Petition Number: 2020-180

General Location Identifier: Tax ID 08901201

From: Robyn Byers, Ph.D. Reviewer: Eric Lemieux, PE

Transportation Summary

Reference (CLDSM standard detail U-03) for street typical.

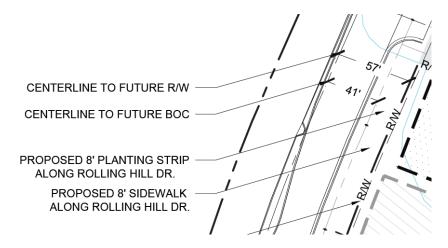
- 3. Revise site plan and conditional note(s) to commit to dedicate 57-feet of right-of-way from the Sugar Creek Road centerline, to accommodate a future 4+ Boulevard road cross section with buffered/separated bike lanes. Label and dimension the right-of-way from the road centerline.
- 4. Outstanding (site plan dated 2021.01.11) The proposed dwelling units exceeds 12 per acre. Per Chapter 20: Subdivision Ordinance, site plan and conditional note(s) revisions are needed to commit to construct an 8 foot planting strip and 8 foot sidewalk along all public street road frontages; currently the site plan shows this for W Sugar Creek Rd only. The wider sidewalk also meets the Charlotte WALKS Policy.

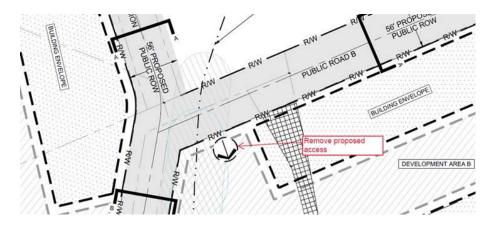
16. **New Comment** (site plan dated 2021.01.11) Site plan revisions and conditional note (<u>Section 3.F.</u>) revisions are needed to clarify that the portions of public right-of-way that may be requested to be abandoned will be subject to the Right of Way Abandonment process that is controlled by North Carolina General Statutes.

will be subject to the Right of Way
- Abandonment process that is controlled by North Carolina General Statutes.
